Access Compliance Report

Public Rights-of-Way

Intersection ID: 45794	Main Street: SHELLVIEW_LN	Cross Street: GRANITE_TRAIL_LN	Location: NW
ADA ID: 0032740474D5	Ramp Type: PerpDiag	Initial Pass/Fail: Fail	Overall Compliance: No
Severity Score: 25			
Codes/Mitigation Info/Possible Solution		Field Measurements/Component Compliance

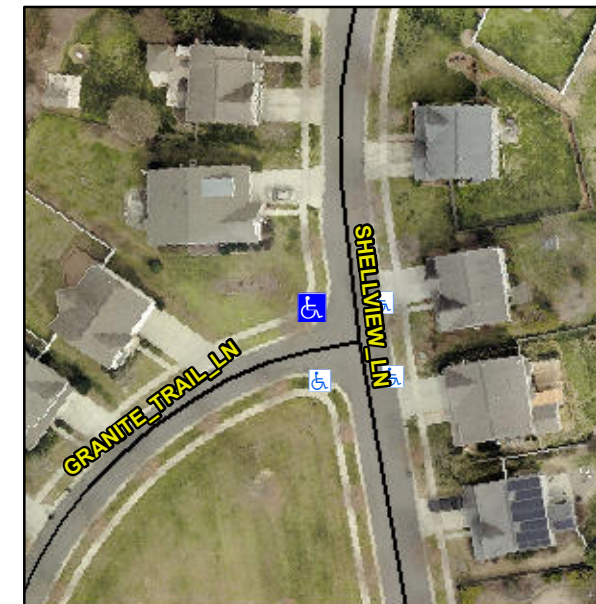
Not Found, R304.5.3

Compliance	Description	Data	Compliance	Description	Data
N/A	Ramp Length (in)	73.5	Yes	Ramp Slope (%)	6.0
Yes	Ramp Width (in)	48.0	No	Ramp XSlope (%)	7.3
N/A	Flare Type LT	N/A	N/A	Flare Type RT	N/A
N/A	Flare Slope LT (%)	N/A	N/A	Flare Slope RT (%)	N/A
N/A	Flare Traversable LT?	N/A	N/A	Flare Traversable RT?	N/A
N/A	Landing Length (in)	N/A	N/A	DWS Provided?	N/A
N/A	Landing Width (in)	N/A	N/A	DWS Contrast?	N/A
N/A	Landing Slope (%)	N/A	N/A	DWS Length (in)	N/A
N/A	Landing X Slope (%)	N/A	N/A	DWS Full Width?	N/A
N/A	Landing Curb? (Y/N)	N/A	N/A	DWS Offset (in)	N/A
N/A	Shared Landing?	N/A			
N/A	Gutter Ponding?	N/A	N/A	Gutter Slope (%)	N/A
N/A	Gutter Lip Ht (in)	N/A	N/A	Gutter X Slope (%)	N/A
N/A	Painted X Walk1?	No	N/A	Painted X Walk2?	No
	X Walk 1 Direction	To S		X Walk 2 Direction	To E
N/A	X Walk 1 Width (in)	N/A	N/A	X Walk 2 Width (in)	N/A
	X Walk 1 Slope (%)	4.5		X Walk 2 Slope (%)	4.1
	X Walk 1 X Slope (%)	1.9		X Walk 2 X Slope (%)	4.1

Remove & Replace Curb Ramp With Two New Directional Ramps or Equivalent.
